**TOWN OF BROOKFIELD, CONNECTICUT
WATER POLLUTION CONTROL AUTHORITY**

**DEAN AND POCONO ROADS SANITARY SEWER EXTENSION
CONTRACT NO. 2026-01**

**ADDENDUM NO. 1
May 29, 2026**

DEAN ROAD PUMPING STATION
 PLAN AND SECTION
 SHEET NO. M-1

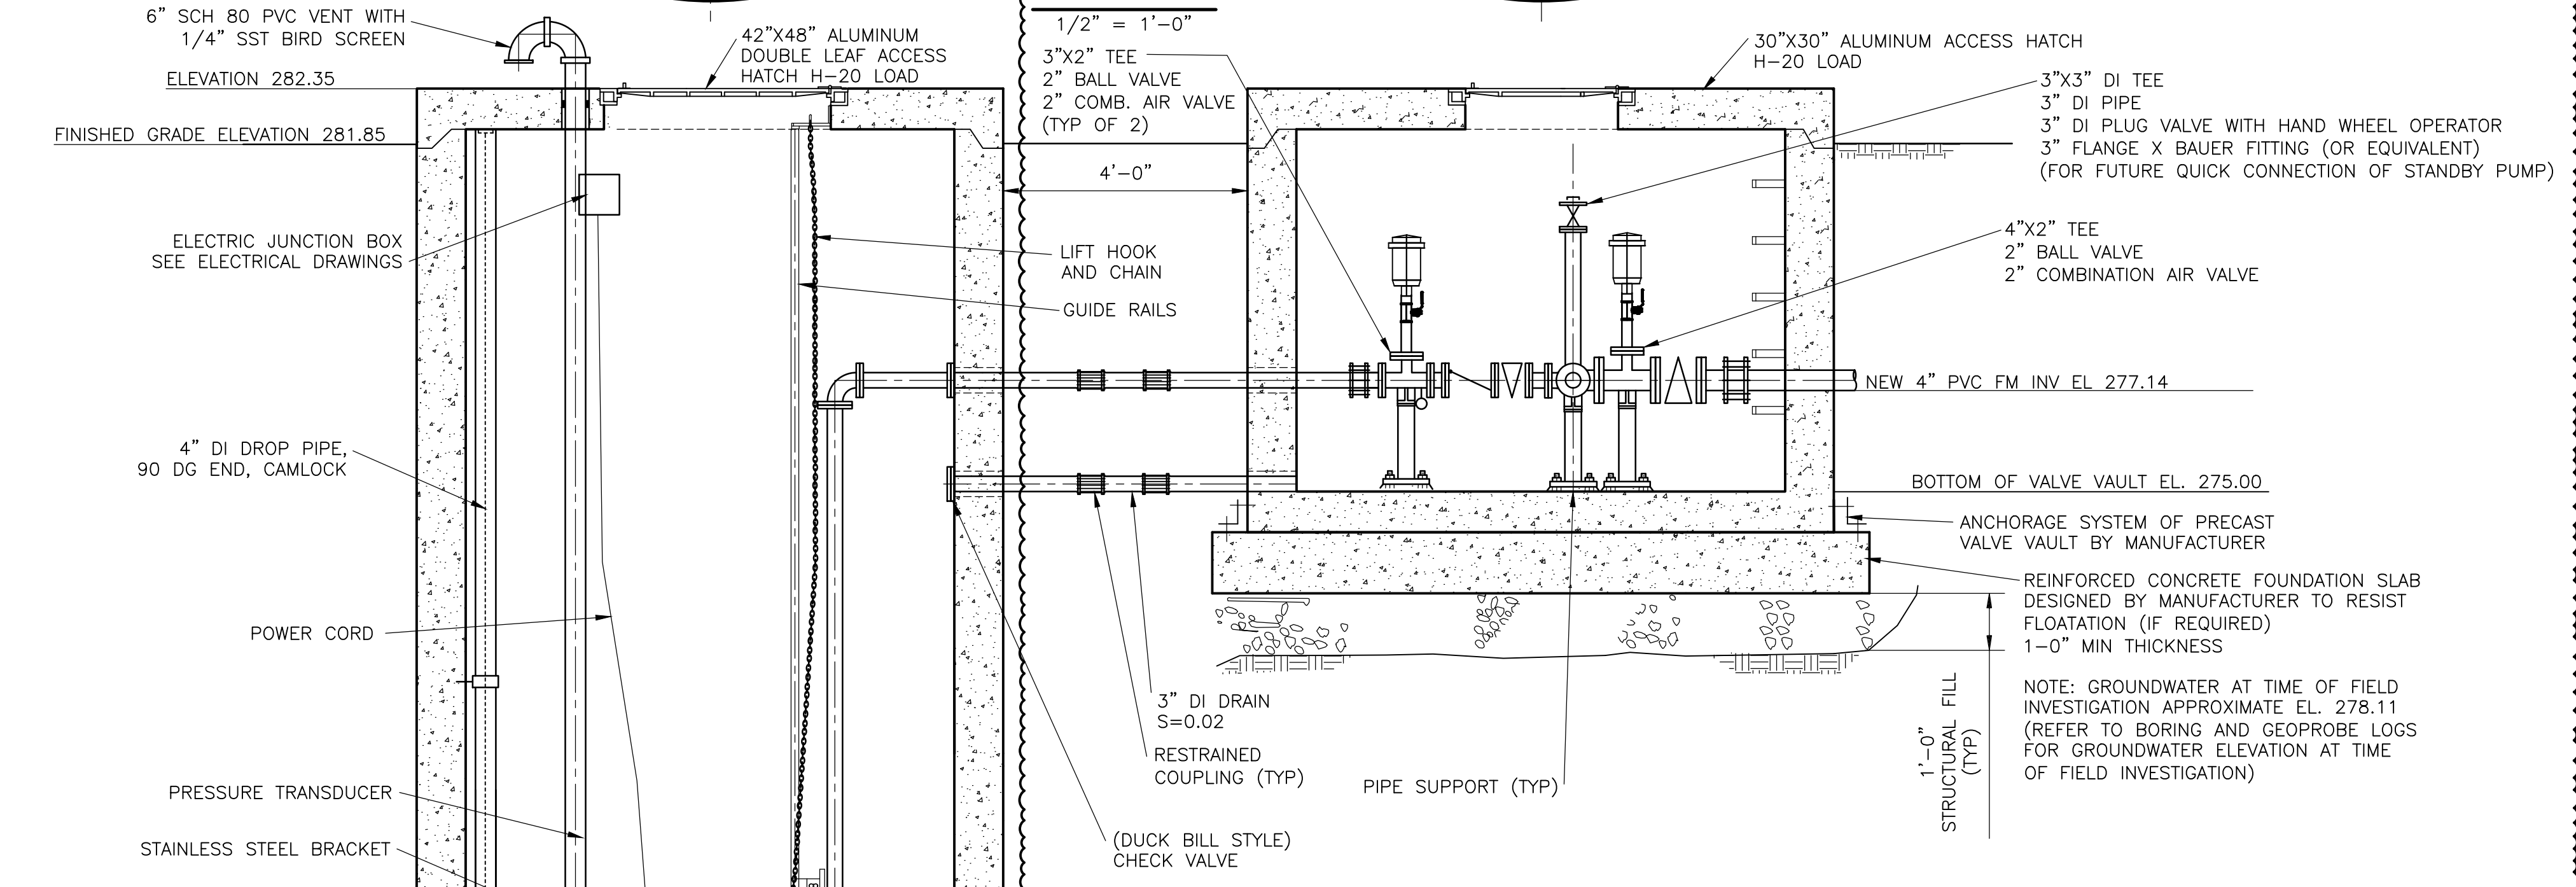
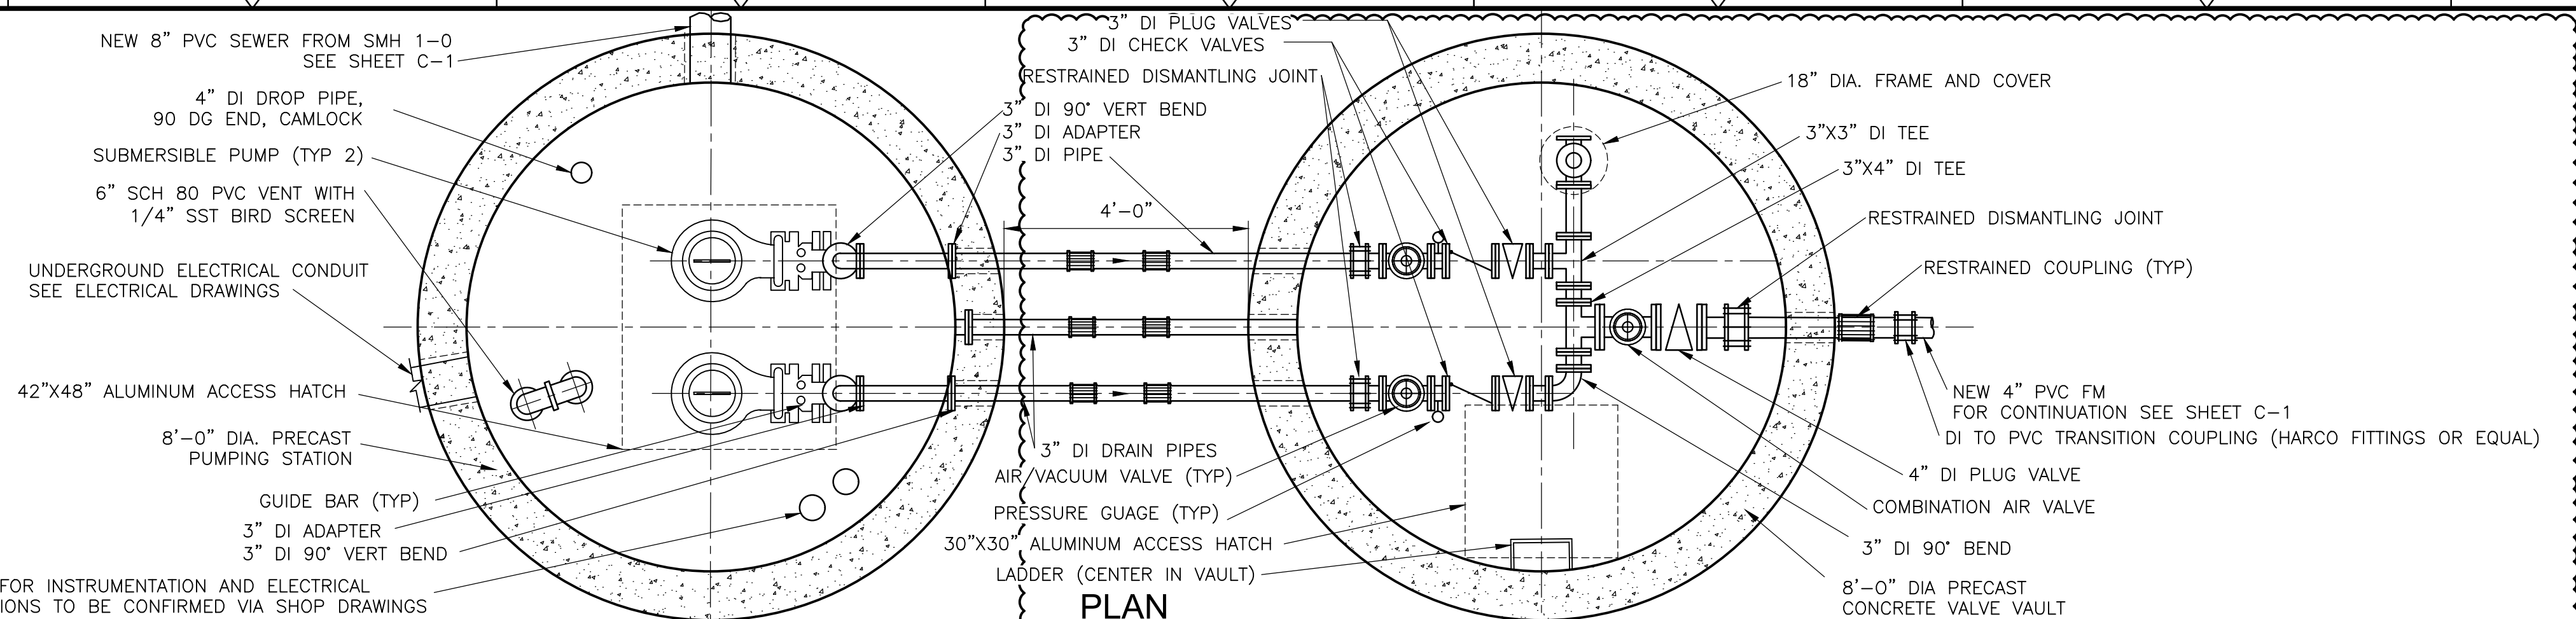
ITEM 1-18 Drawing M-1, DEAN ROAD PUMPING STATION, PLAN AND SECTION: DELETE Drawing M-1 and REPLACE it with the revised Drawing M-1, included as Attachment No. 4.

ATTACHMENT NO. 5
SKETCH SK-1.1, REVISION TO DRAWING CD-2,
LOW-PRESSURE SANITARY SEWER EXTENSION

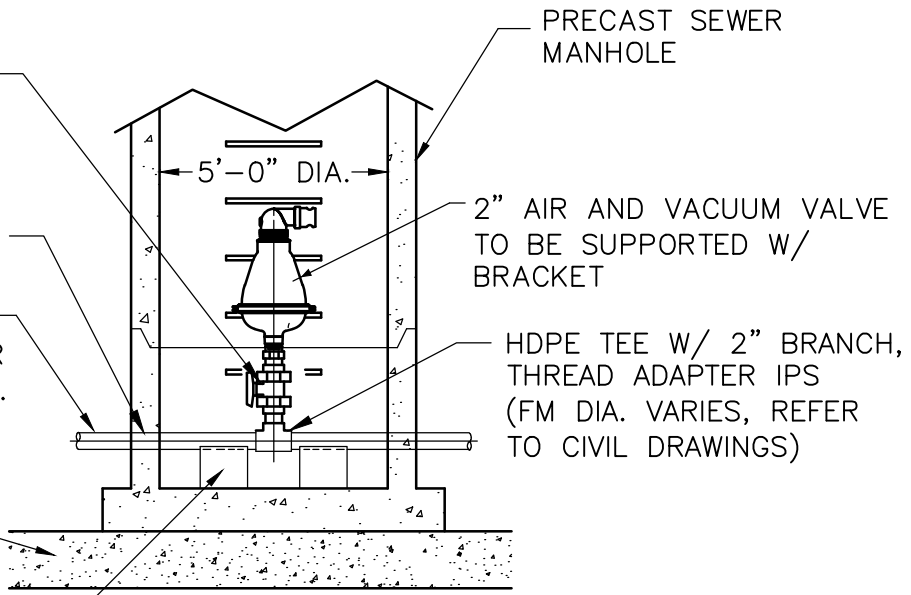
ITEM 1-19 At location D-4 on Drawing CD-2, DELETE Detail E, AIR AND VACUUM RELIEF VALVE MANHOLE, and REPLACE it with revised Detail E, AIR AND VACUUM RELIEF VALVE MANHOLE as shown in Sketch SK-1.1, included as Attachment No. 5.

NOTE:
TEE BRANCH AND VALVE SIZES TO BE CONFIRMED DURING SHOP DRAWING SUBMITTAL PROCESS.
